ISSUE: Permit to Demolish/Capsulate (partial) and Certificate of Appropriateness for alterations and addition

APPLICANT: Bilgehan Yalcin

LOCATION: Old and Historic Alexandria District
105 Queen Street

STAFF RECOMMENDATION

Figure 1: Proposed roof terrace Option A

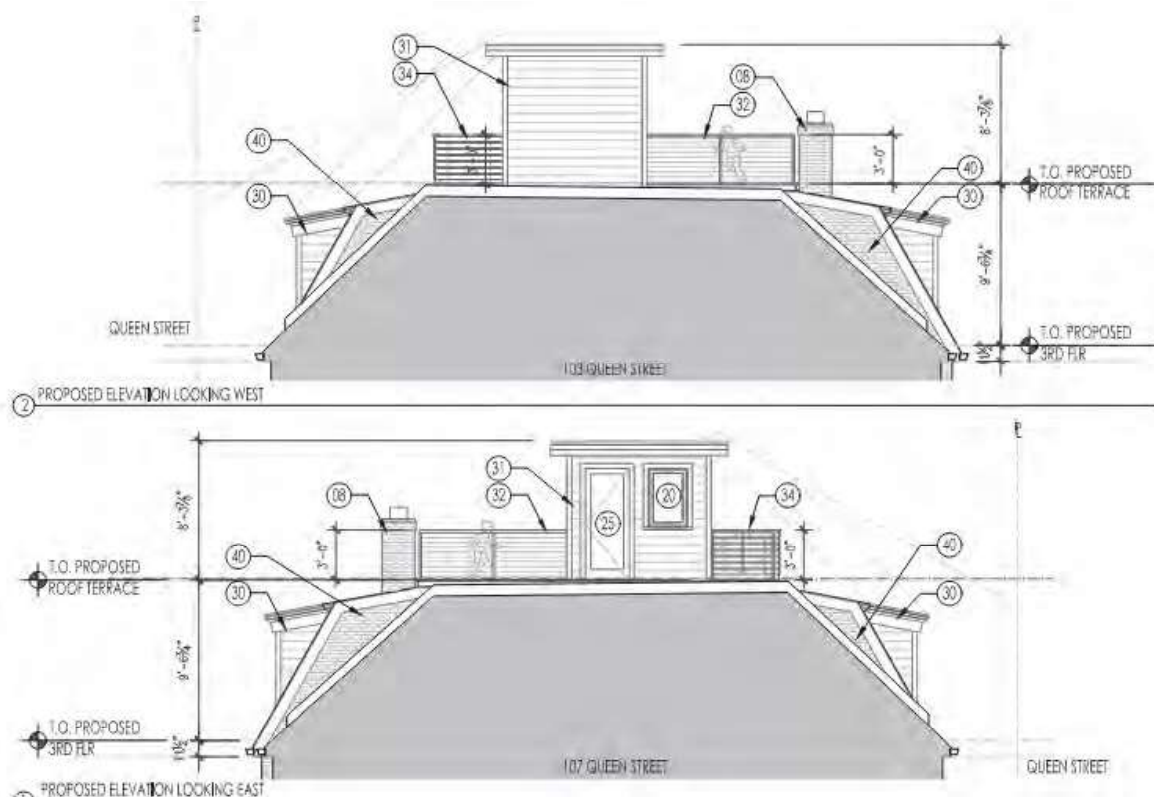
Staff finds that the three proposed roof deck options comply with the *Design Guidelines* because they do not “hide, obscure, or cause the removal of historic architectural details.” They also utilize “materials which are sympathetic to the building materials found in the historic districts.” In that same vein, the project fulfills the *Design Guidelines*’ parameter that “Material should not be used on a roof deck that detracts from the historic architecture of a structure.” Additionally, the proposed roof decks do “not interfere with the historic roofline of a building.” In short, the proposed decks comply with every guideline relating to roof decks in the historic districts. Although visible from a public right of way, the proposed roof decks do not negatively affect the overall appearance of the neighborhood. This late 20th-century community features numerous additions and alterations which contribute to its unique and creative streetscape. As the Board has noted on several occasions, Alexandria should not be architecturally frozen in time like Williamsburg, but instead should continue to be a vibrant and growing community.

Staff therefore finds all options appropriate and recommends approval of the project, as submitted.

Figure 2: Proposed roof terrace Option B

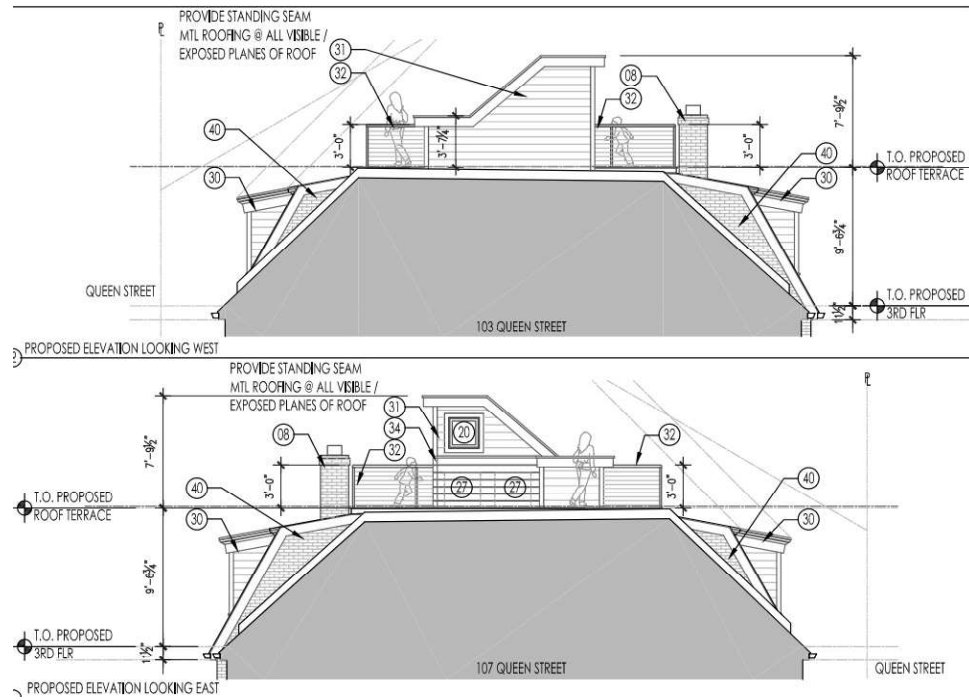
The application initially proposed Option A only, but after input from neighboring homeowners, the architect devised Options B and C as viable alternatives to assuage their concerns. Staff finds all three options appropriate. Note that sloped surfaces will be clad in standing seam metal, while vertical surfaces will be clad in fiber cement. Figure 5 above depicts Option A as seen from Queen Street. Figures 6 and 7 below depict Options B and C from the same vantage point. Option B has a smaller sloped stair enclosure and Option C has a smaller squared stair enclosure. Figure 8 depicts the north/rear elevation of Option A; figure 9 depicts the north/rear elevation of Options B and C.

Figure 5: Proposed front/south elevation

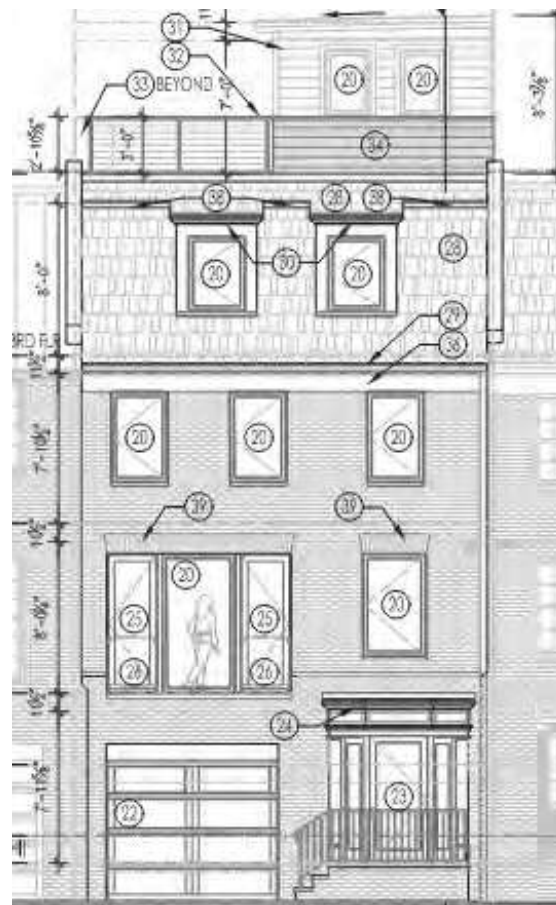
The applicant is simulating a historically accurate Colonial Revival style gambrel roof form in lieu of the existing faux mansard roofline. Additionally, the single shed dormers on the front are appropriately integrated with the roof and appropriate in scale. The rear dormer is also in scale with the redesigned roof. The Board approved a similar roof type in this community at 123 Quay Street on July 19, 2017 (BAR2017-00209 & BAR2017-00210).

The doors, windows, garage doors, light fixtures meet BAR *Design Guidelines* and comply with the *BAR Policies for Administrative Approval*. The proposed windows and doors, with glazing which complies with the Board's *Policies for Administrative Approval for Windows*, are both acceptable and appropriate. Replacing the cracked cast stone lintels with brick jack arches will improve the overall look of the primary elevation without detracting from its architectural character. Likewise, the enlarged windows on both elevations and proposed roof/dormers complement the existing design of the townhouse. The remaining alterations replace worn out and degraded materials. The proposed materials are high quality and appropriate for this brick townhouse. Wholesale façade alteration in a more contemporary style has been supported by the BAR in the past decade with many examples in this development. Unlike many other modernized homes in the community, the proposed design for 105 Queen Street updates the home without straying far from its pseudo-Colonial Revival roots. Staff notes that first floor of the rear/north elevation is not visible from any public right of way, but the top story and roof can be seen from North Union Street.
